Reference SSM62297

Models LR2 / L359

Title L359 Freelander front carpet mat fit

Mats Retention Clips

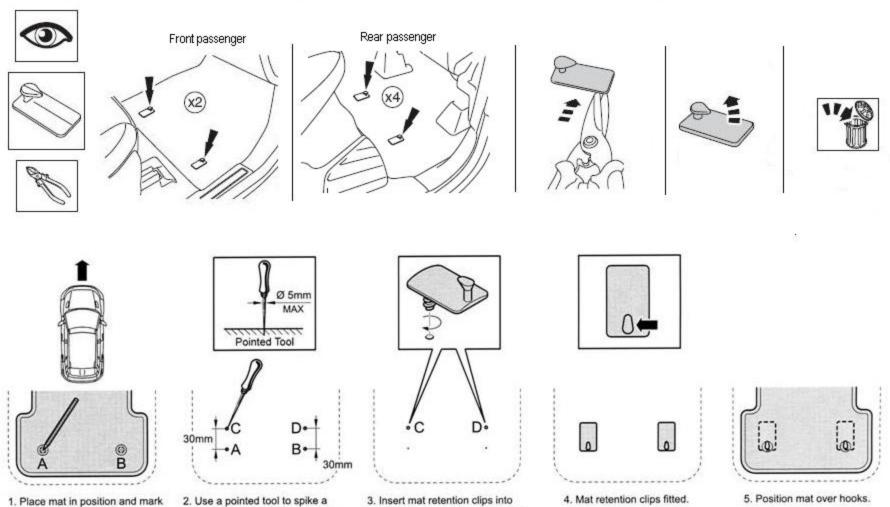
Front carpet clip location may be incorrect

<u>Cause:</u> Content Poor clip position

If it is seen that the front carpet mat does not fit correctly

follow the attached instruction

points C and D and turn clockwise

until they turn freely.

small hole in the carpet at points C and D, 30mm forward of marks

A and B.

centre of hole positions.

4. Mat retention clips fitted. 5. Position mat over hooks.
